**MODIFICATION REQUEST:
WestConnex M4 East**

***Modification to SSI Boundary
SSI 6307 (MOD 2)***

Secretary's Environmental Assessment Report
Section 115ZI of the
Environmental Planning and Assessment Act 1979

January 2017

Figure 1: Approximate location of proposed stormwater outlets into Dobroyd Canal

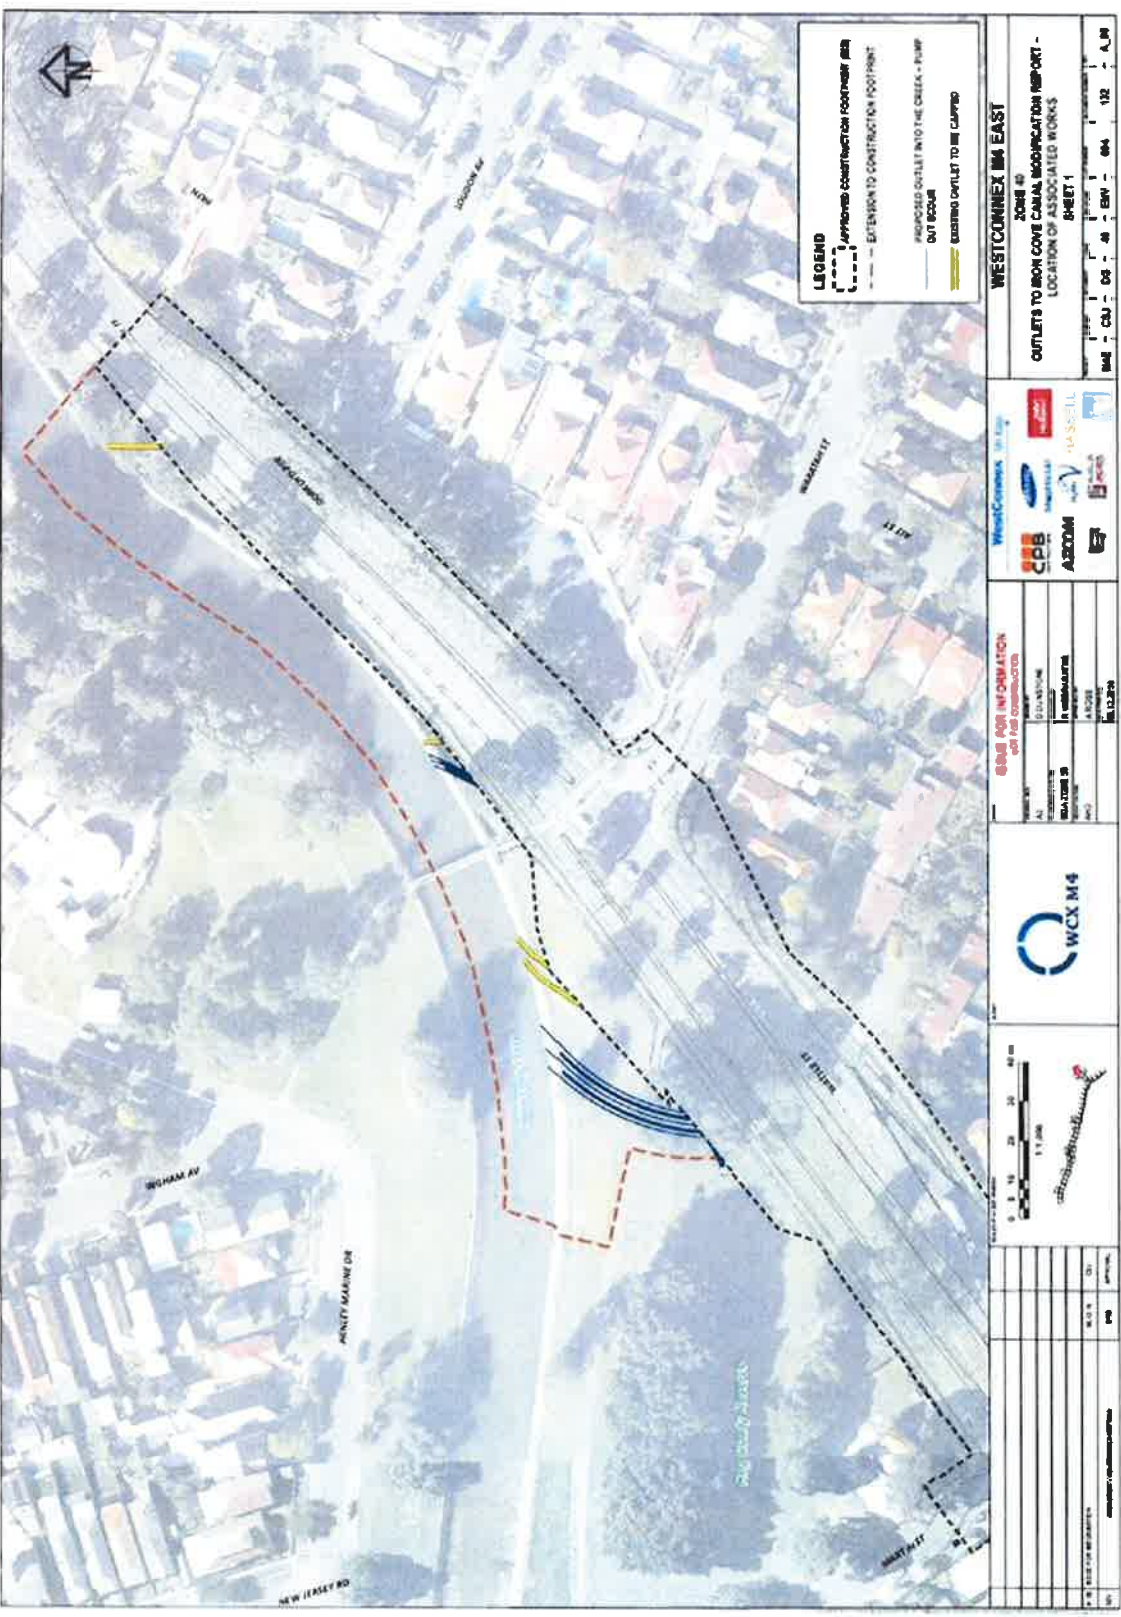
- capping of the existing Sydney Water box culvert and two other outlets as illustrated in Figure 1;
- installation of a twin cell 2.7 metre wide by 1.2 metre high box culvert approximately 14 metres upstream of the existing box culvert; and
- installation of a single 1050 millimetre diameter pipe culvert upstream of the proposed box culvert comprising two 900 millimetre stormwater pipes connecting into Dobroyd Canal, and a gross pollutant trap.

The approximate location of the proposed outlets is shown in Figure 1 and will be confirmed following exposure of the canal wall.

The proposed box culvert will comprise two 2.7 metre x 1.2 metre openings with the total width of the opening being approximately 12 metres, with wing walls extending out approximately five metres and mirroring the grade of the existing concrete banks. This is larger than the existing structure that it will replace which is a 2.6 metre wide by 1.4 metre high box culvert. The existing box culvert will be grouted closed following commissioning of the new connection.

The proposed new box culvert will be located approximately 14 metres downstream of the new culvert. The Department acknowledges that although the new box culvert will be lower than the existing box culvert, it will be twice the length and therefore have greater visibility along the canal wall. However, it would only be visible during low and mid tide to receivers standing on the northern side of the canal or those crossing the footbridge. In addition, the Department notes that culverts and stormwater connections are common in canals of this type. Therefore, the Department considers the visual impact acceptable.

The single pipe culvert with two 900 millimetre stormwater pipes connecting into the canal will have an opening width of approximately six metres at the canal surface. The pipe culvert would be similar in size to existing outlets along the canal. As such, the Department considers that the visual impact would be minor.

Notwithstanding, and in accordance with the recommendations of the heritage impact assessment, the Department is of the opinion that any works on Dobroyd Canal should be undertaken in consultation with a suitably qualified and experienced heritage consultant and Sydney Water's Lead Heritage Advisor. Further, all reasonable steps should be undertaken to ensure that the lateral extent and degree of impact to the canal fabric is minimised. A condition to this effect has been recommended.
